Issue:

The modelled gasifier voids provided in 'Arrow Energy - Additional Information to support Hopeland Stage 2' (v1.0 dated 23/06/2026) shows a significant difference between the burn cavities reported by AECOM (2018) and total volume generated by multiplying seam thickness and area calculated by Perkins (2018), with the latter being significantly higher than the former.

Additional cross-sections (Figure 2 and Figure 3) were provided in 'Arrow Energy - Additional Information to support Hopeland Stage 2' (v1.0 dated 23/06/2026) to expand on the conceptual site model. Further clarifications are required on these cross-sections and conceptual site model.

Figure 2-1 Conceptual Site Model of former Hopeland UCG

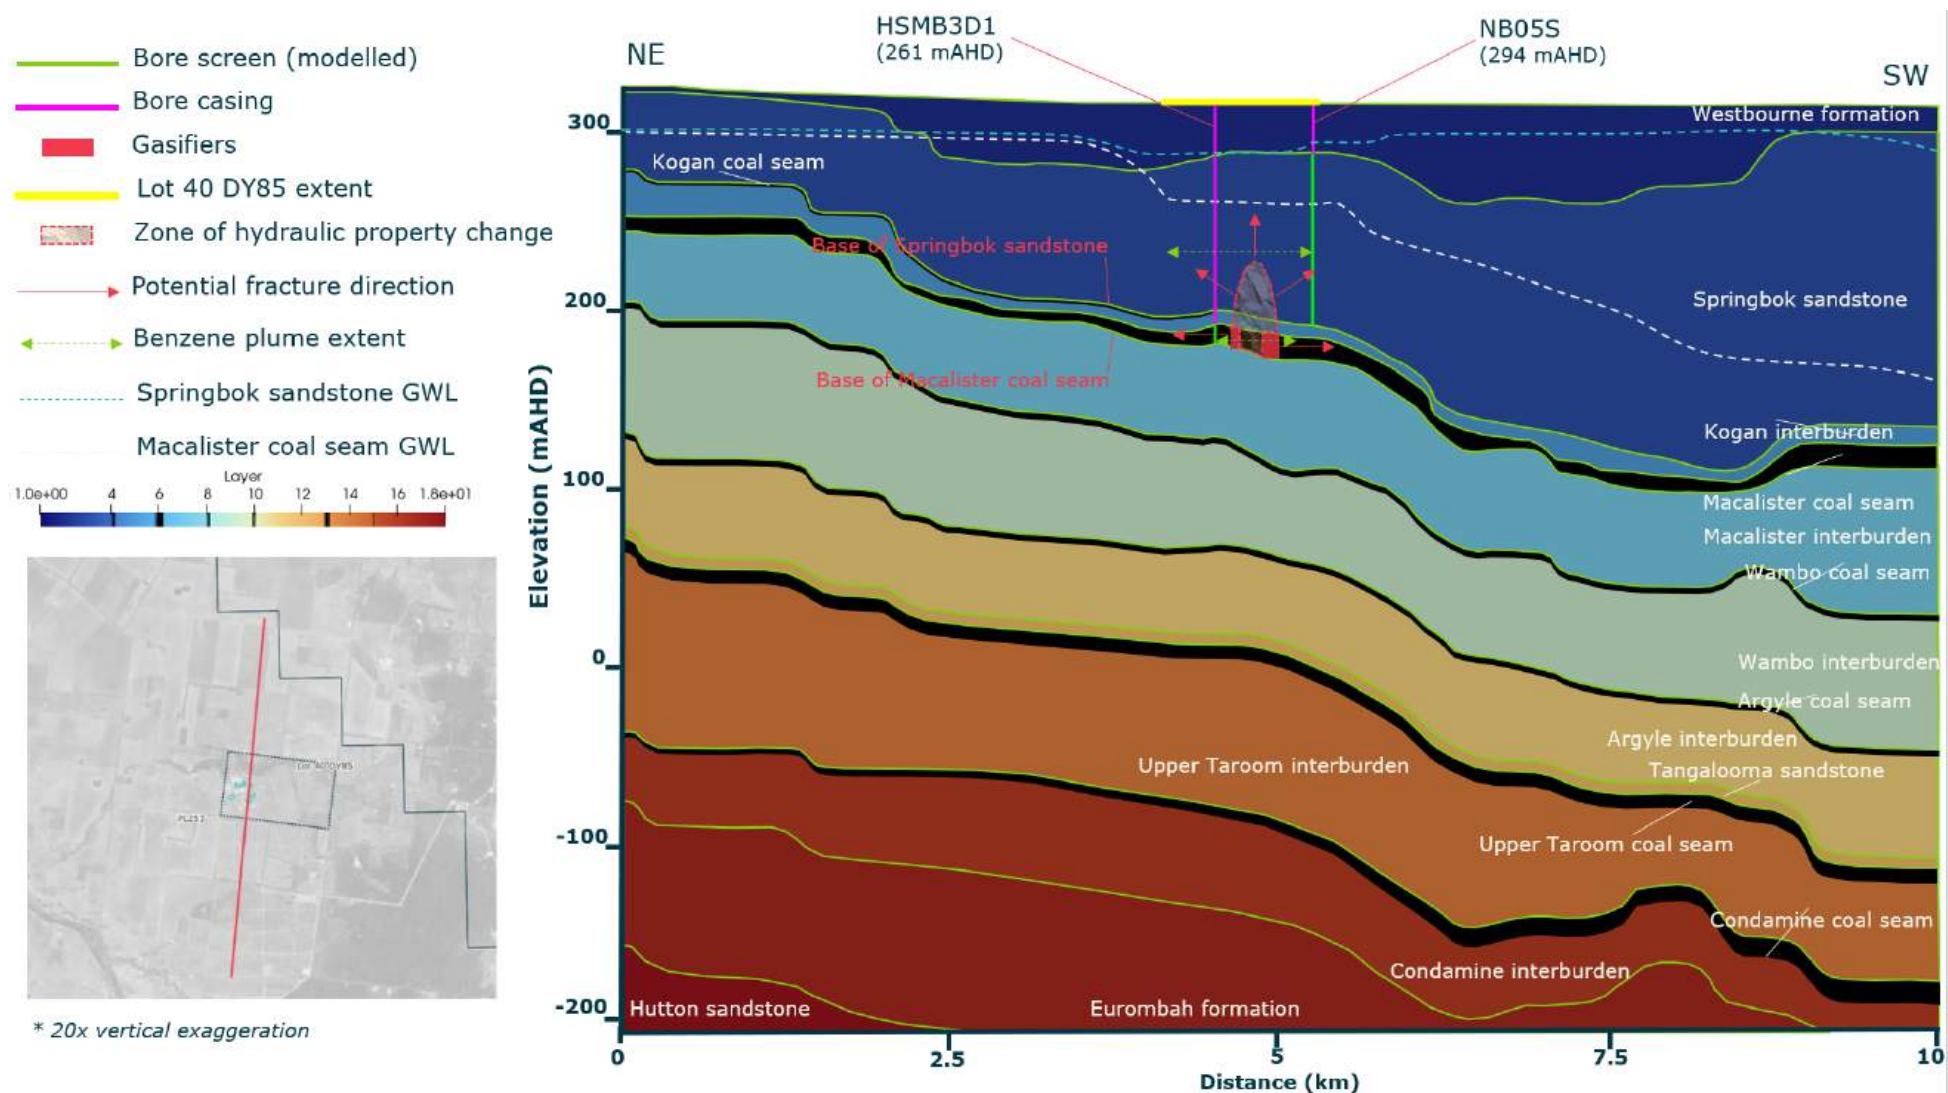
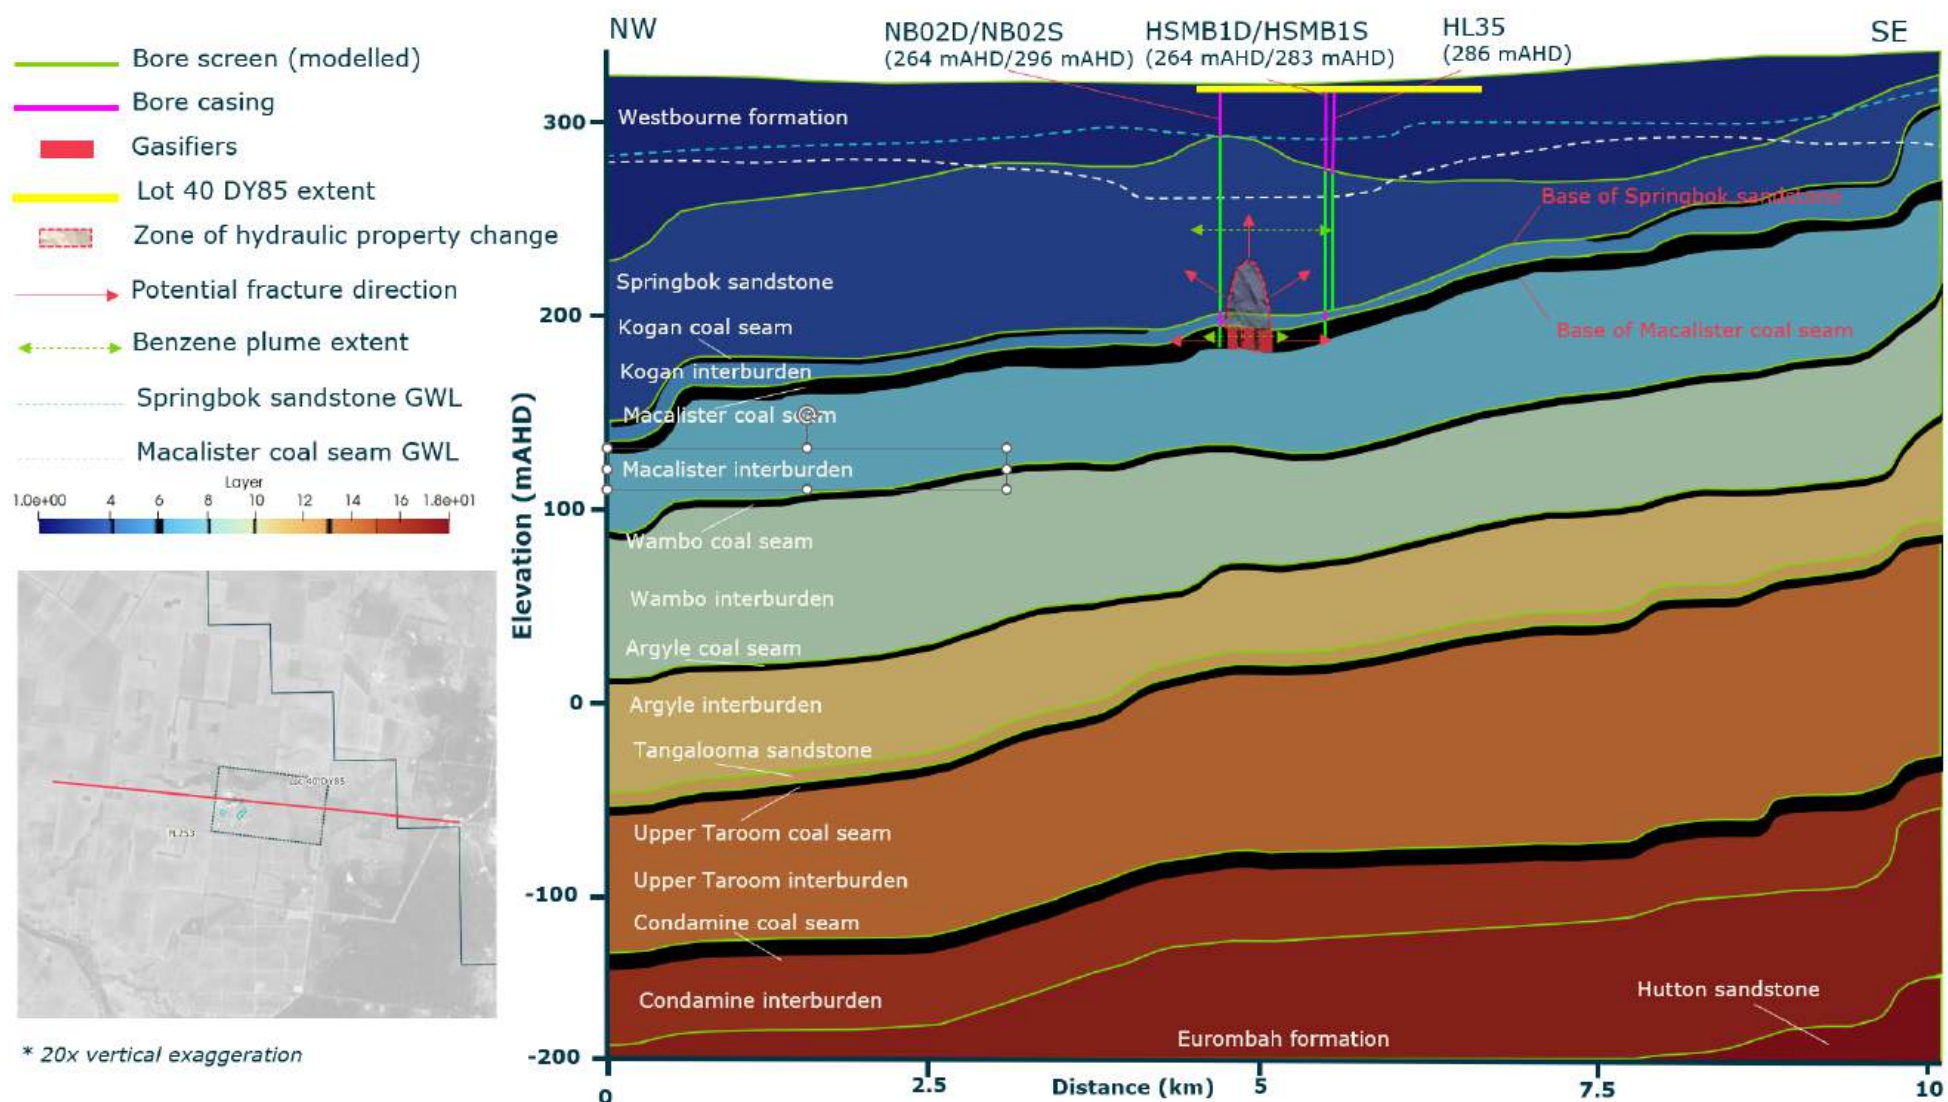
2. The horizontal scale is missing in these cross-sections. Provide updated Figure 2 and Figure 3 cross-sections including the horizontal scale. Writing/ labelling groundwater elevation (in mAHD) next to the observed water level in the bores as well as key hydro-stratigraphic units (e.g. base of the Macalister coal seam) would also be helpful.

3. Clarify if the extrapolated hydraulic heads presented in these figures are based on modelling.

Figure 2 and Figure 3 cross-sections have been revised to include a horizontal scale. In addition, groundwater elevations (mAHD) corresponding to the observed water levels in the bores have been annotated, and key hydrostratigraphic units, including the base of the Macalister coal seam, have been labelled to improve clarity and interpretation. The updated figures are included in the updated model report (refer to Figure 2-1 of the attached "**PL253 Groundwater Impact Assessment - Clynes Road FDP**" report).

Yes, the extrapolated hydraulic heads presented in these figures are derived from model results corresponding to the end of 2025.

Project No.	Client	Figure No.
411001-00917	Arrow	4-6
Notes:		
Project CRS: GDA94 / MGA zone 56		
Last Saved: 22:44 03/08/2026		
Filename: Figure_4-6_GW_cal_end_v2		
Exported by User: Mohsen.Azadi		
Project Exported: 22:48 03/08/2026		
References:		
N/A

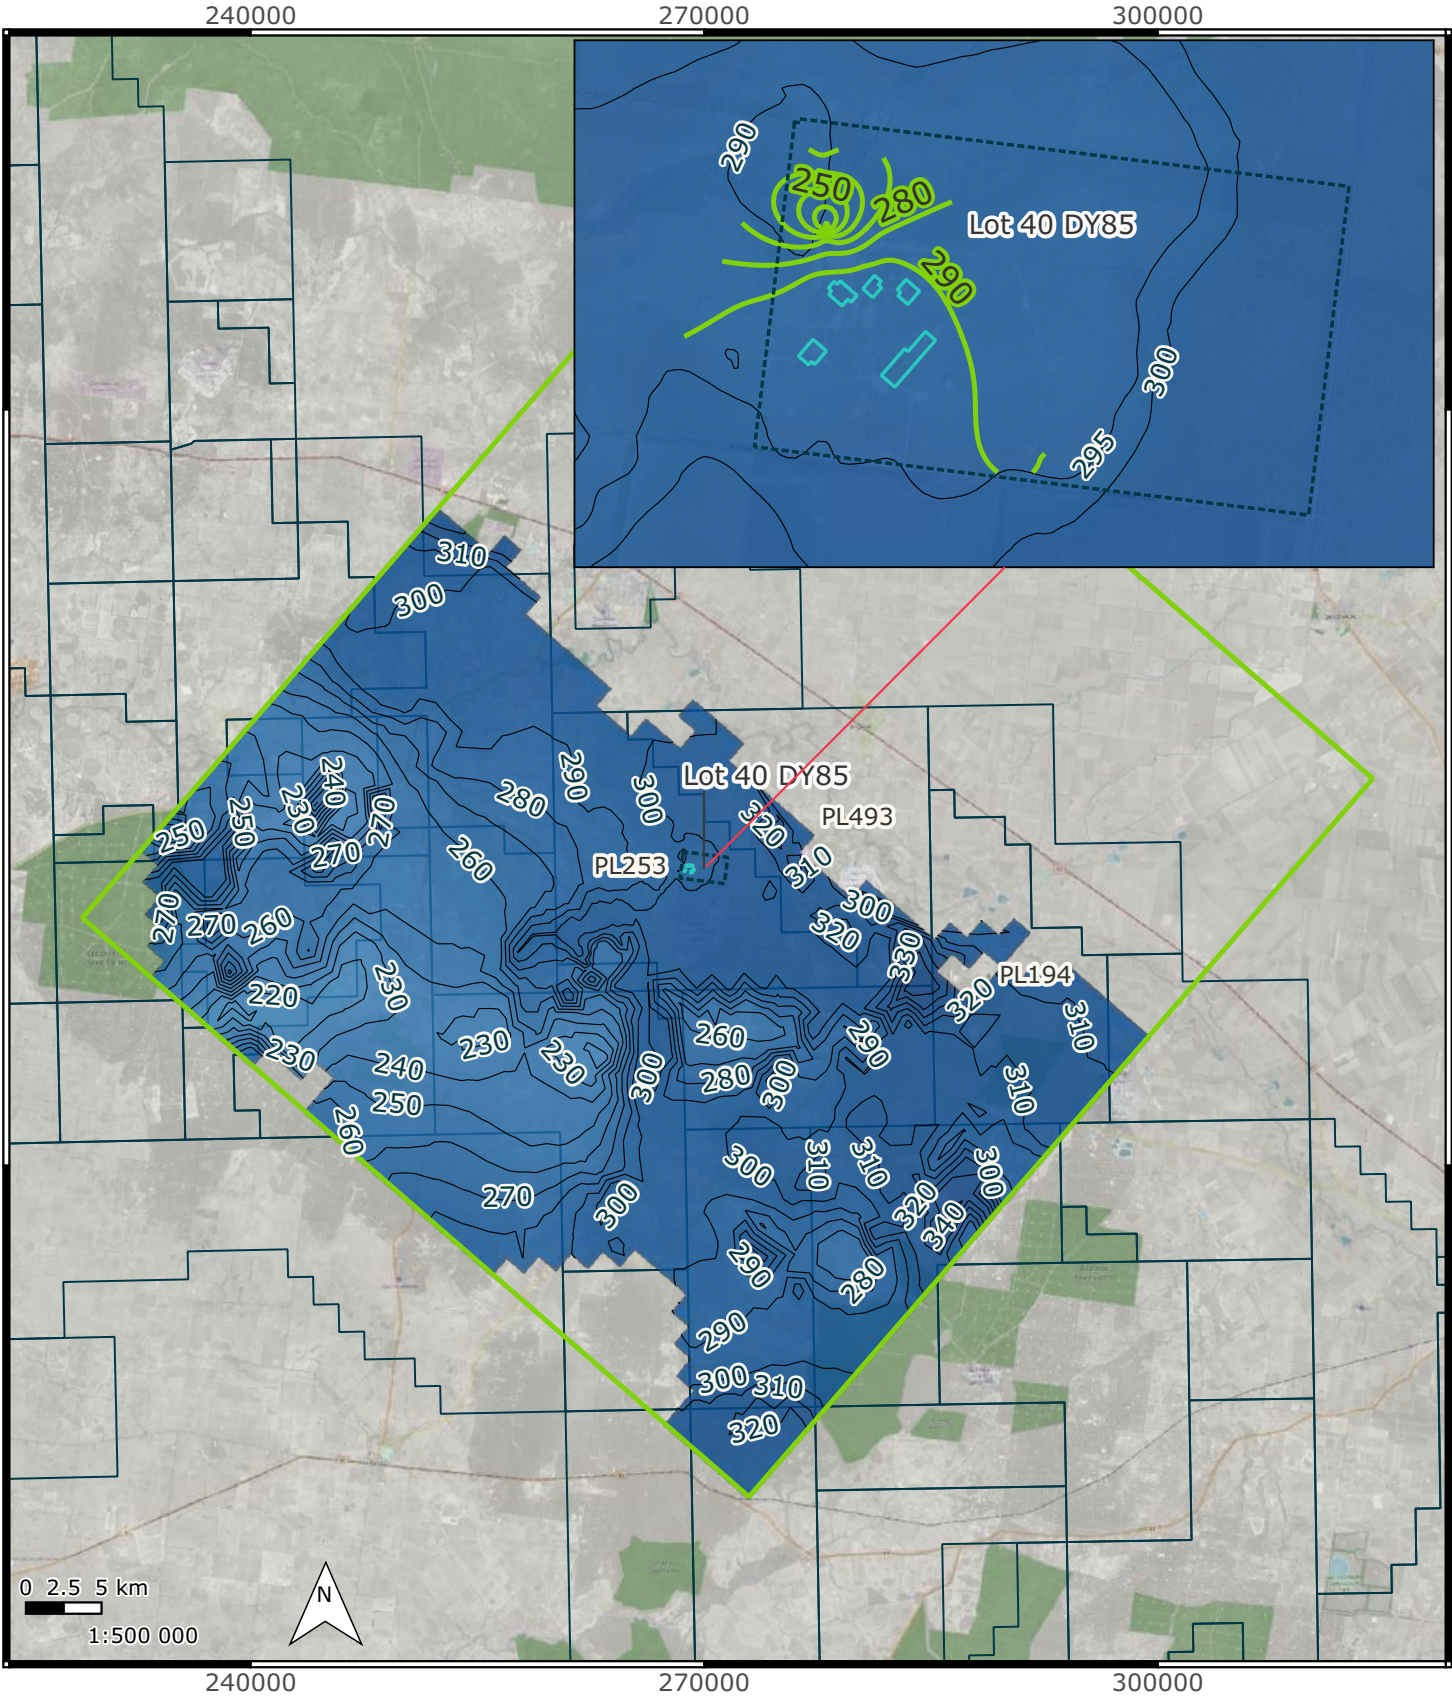
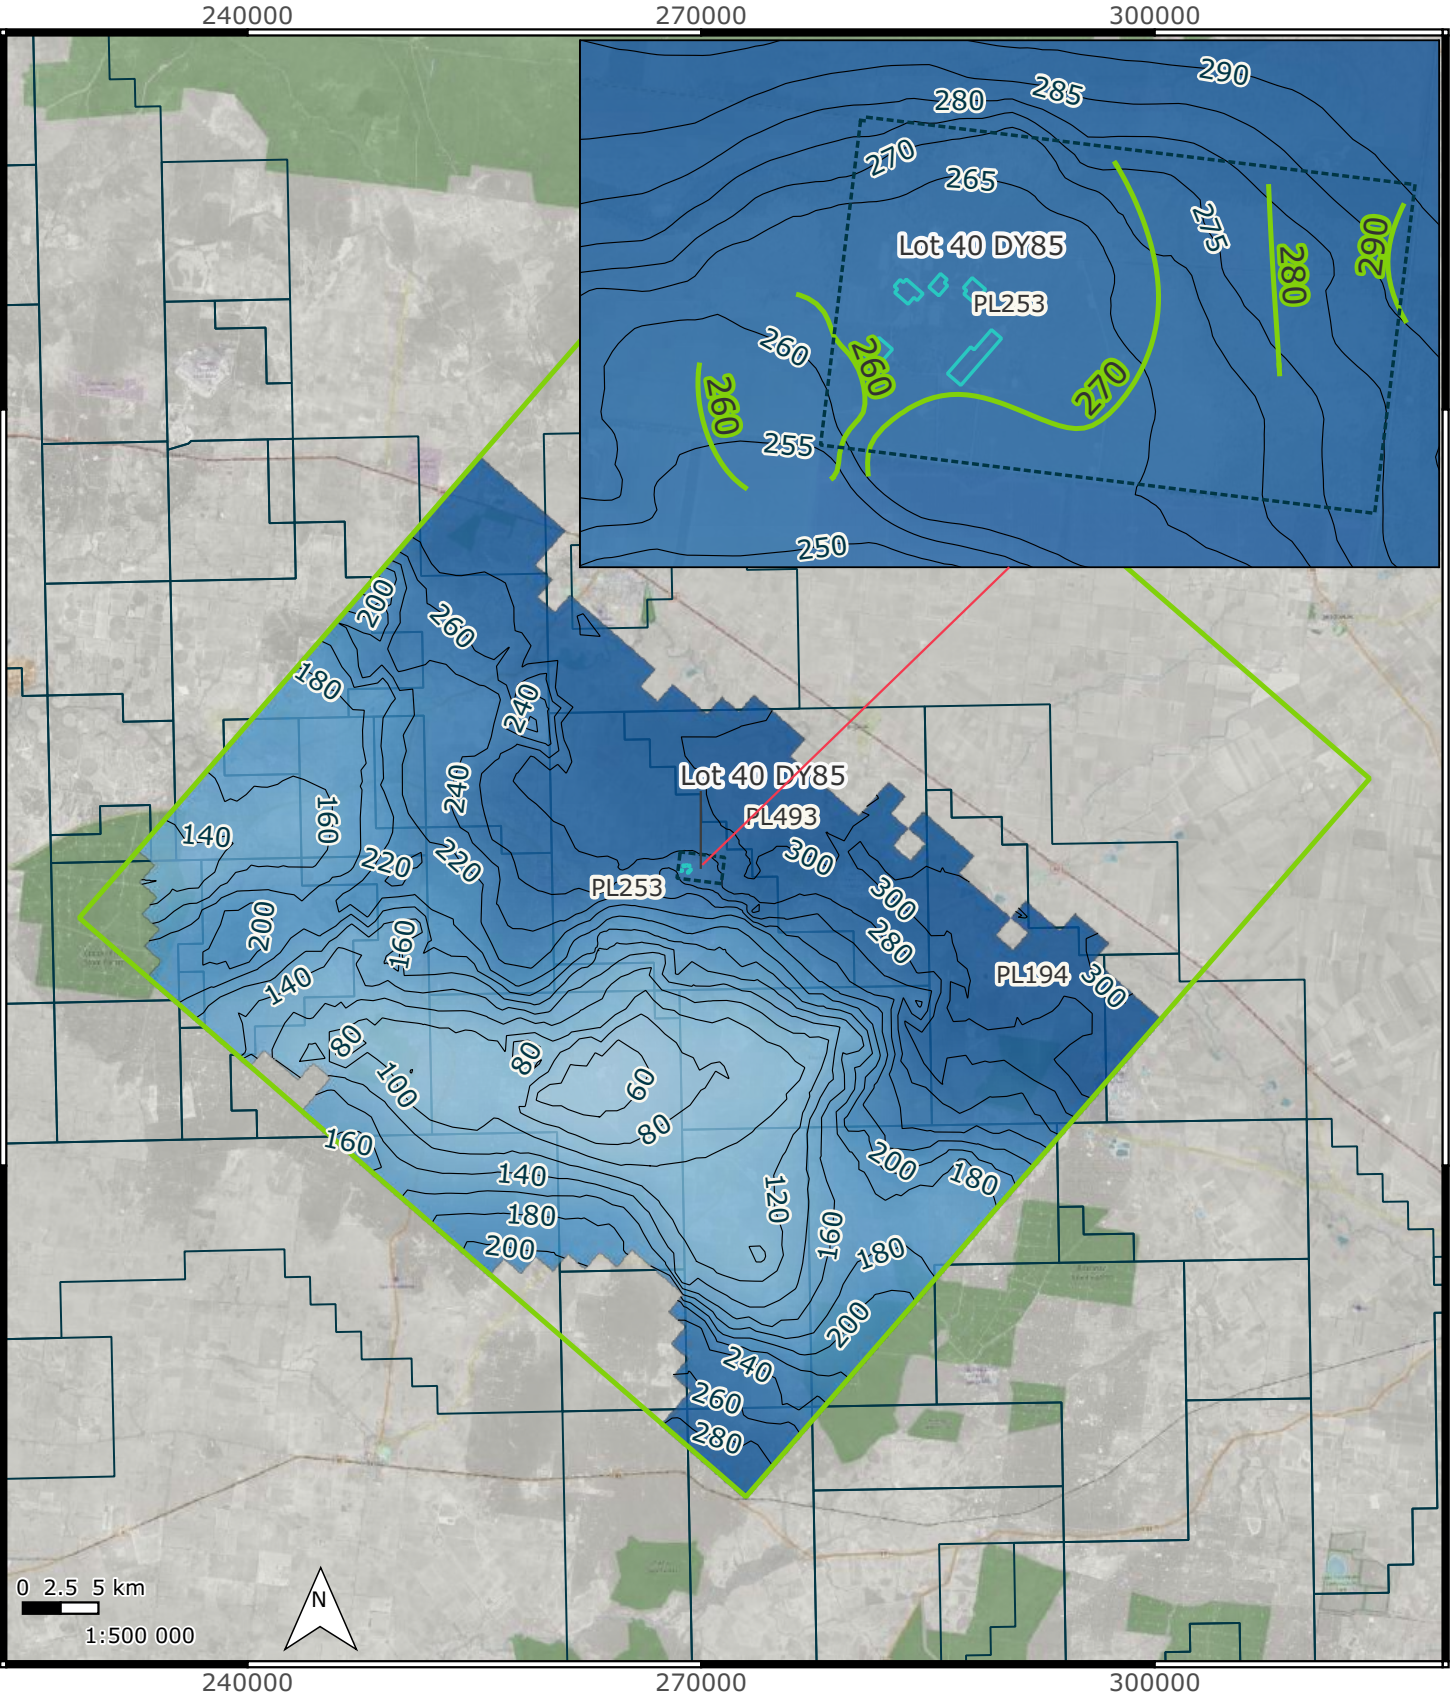
The response provided in 'Arrow Energy - Additional Information to support Hopeland Stage 2' (v1.0 dated 23/06/2026) for inward flow toward Lot 40 DY85, in the Springbok Sandstone (Figure 4), through to the end of the recovery period (2225) is not satisfactory. Inappropriate model parameters used at the gasifier and gasifier affected areas may be impacting the flow pattern and time of recovery.

7. Clarify and provide further justification for the model parameters used.

The updated ensemble predictions (discussed in the previous comment) indicate no material change in the predicted groundwater flow directions at the end of the recovery period. Please refer to response to Action 6.
